## ADDENDUM NUMBER THREE

## HIXSON COMMUNITY CENTER GYM ROOF

## FOR THE CITY OF CHATTANOOGA, TENNESSEE Contract Number Y-19-002

## NOTES FROM THE PRE-BID MEETING

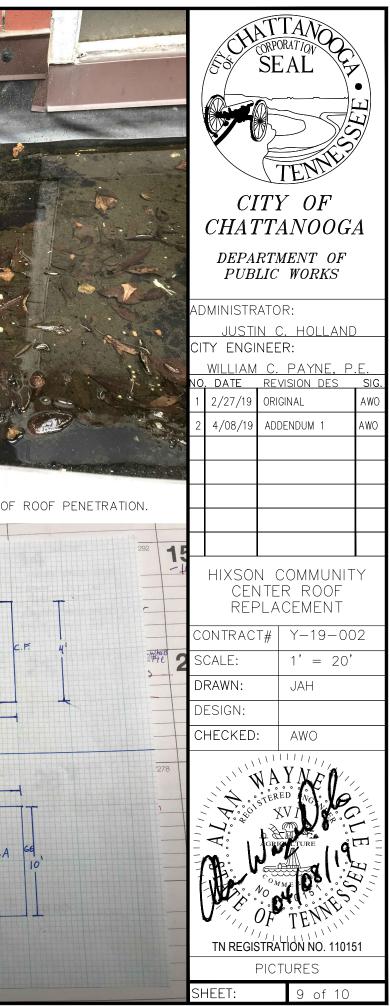
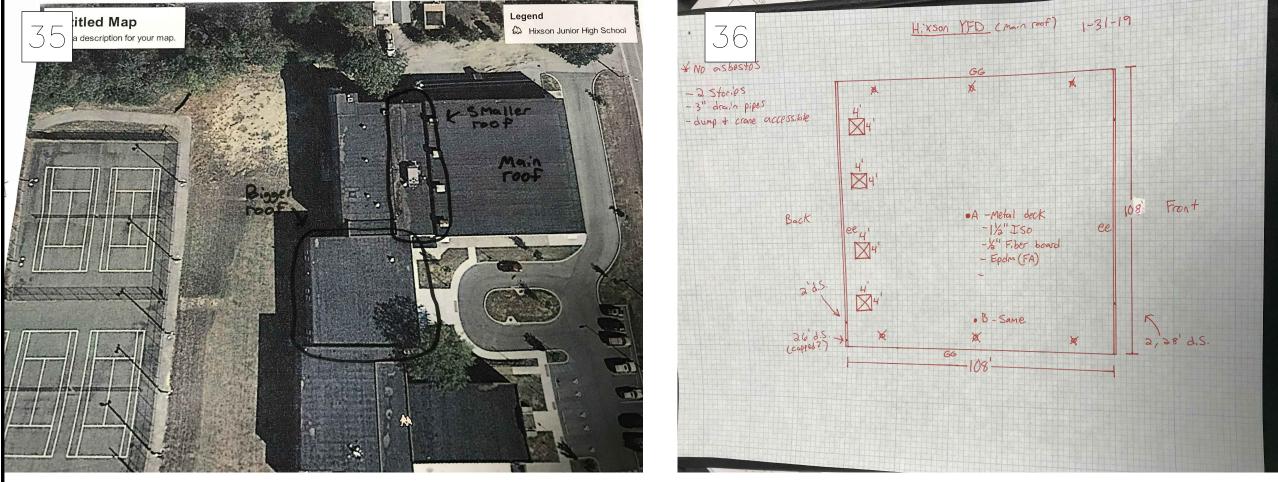
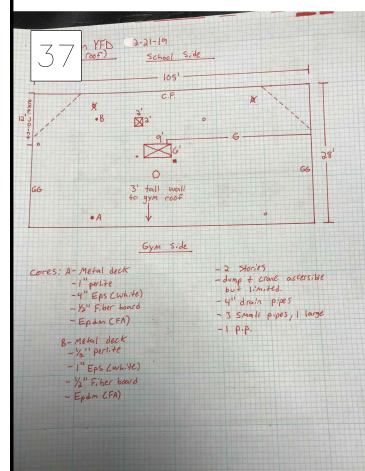
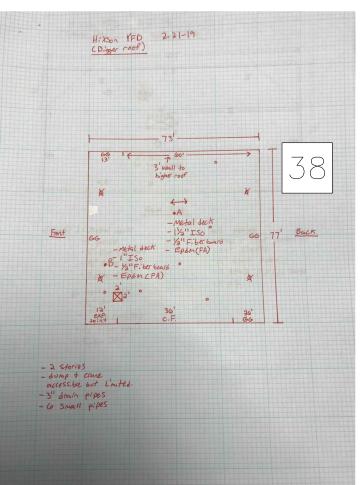
A Core Diagram has been provided by JDH for the roof area. It is included with this addendum, sheets 9 and 10.
